<b>Project</b>	<b>IEEE 802.16 Broadband Wireless Access Working Group</b> < <a href="http://ieee802.org/16">http://ieee802.org/16</a> >	
<b>Title</b>	<b>Performance Management Primitives for Performance Monitoring Procedures</b>	
<b>Date Submitted</b>	<b>2005-09-12</b>	
<b>Source(s)</b>	ZTE corporation, CATR	fu.lianxu@zte.com.cn
	Lianxu Fu	kang.honghui@zte.com.cn
	Honghui Kang	xu.ling@zte.com.cn
	Ling Xu	jqian@ztesandiego.com
	Jeff Qian	
	Cancan Huang	
	Ernie Tacsik	
	Xiaolu Dong	
<b>Re:</b>	Contribution on comments to IEEE 802.16g-05/008	
<b>Abstract</b>	In this contribution, we propose to define some primitives for performance monitoring management.	
<b>Purpose</b>	Adoption	
<b>Notice</b>	This document has been prepared to assist IEEE 802.16. It is offered as a basis for discussion and is not binding on the contributing individual(s) or organization(s). The material in this document is subject to change in form and content after further study. The contributor(s) reserve(s) the right to add, amend or withdraw material contained herein.

# Performance management primitives for Performance Monitoring Procedures

Figure 1 Example of primitive flow of Performance monitoring

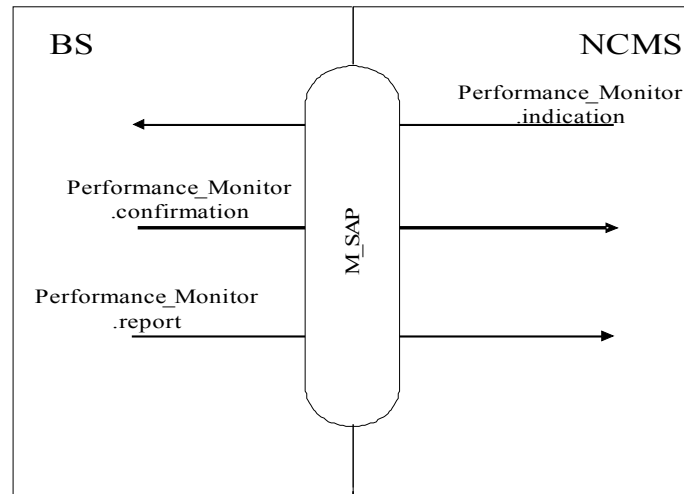
As shown in Figure 1, the procedure is as the following:

[Insert section 14.5.4 as follow]

Figure XXX shows the example of performance monitoring procedure
